**SUBJECT: FINAL REPORT—INDEPENDENT CONFIRMATORY SURVEY OF
THE NUCLEAR RESEARCH LABORATORY AT THE UNIVERSITY OF
ILLINOIS, URBANA-CHAMPAIGN, ILLINOIS; (DOCKET NO. 50-151;
RFTA NO. 12-006)
DCN 5173-SR-01-0**

INDEPENDENT CONFIRMATORY SURVEY OF THE NUCLEAR RESEARCH LABORATORY AT THE UNIVERSITY OF ILLINOIS URBANA-CHAMPAIGN, ILLINOIS

Final Report

Fig. 1. Confirmatory Sample Locations for the Bioshield and N16 Coolant Tunnel

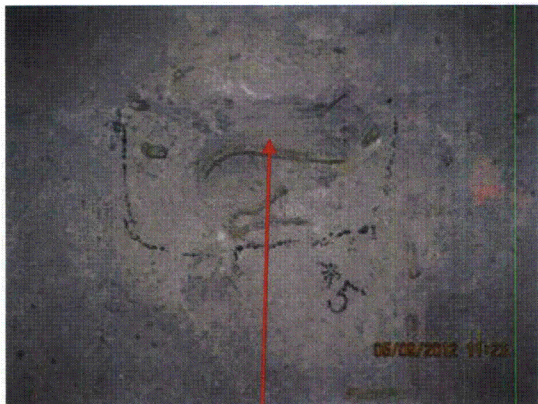
ORAU collected four concrete samples during confirmatory survey activities; three within the bioshield and one in the N16 coolant tunnel (Fig. 1). Samples were obtained from these areas due to increased activity measurements or at the request of the NRC. An additional five volumetric concrete samples collected and previously analyzed by the licensee were selected by the NRC and provided to ORAU for an inter-lab comparison.

Additional concerns were identified in the radiological analysis of the four confirmatory concrete samples collected from the bioshield and coolant tunnel. Review of the analytical results revealed concentrations of Co-60 in excess of the 0.5 pCi/g release limit for all samples, and two samples had concentrations in excess of the 1.1 pCi/g Eu-152 release limit (Table B-2).
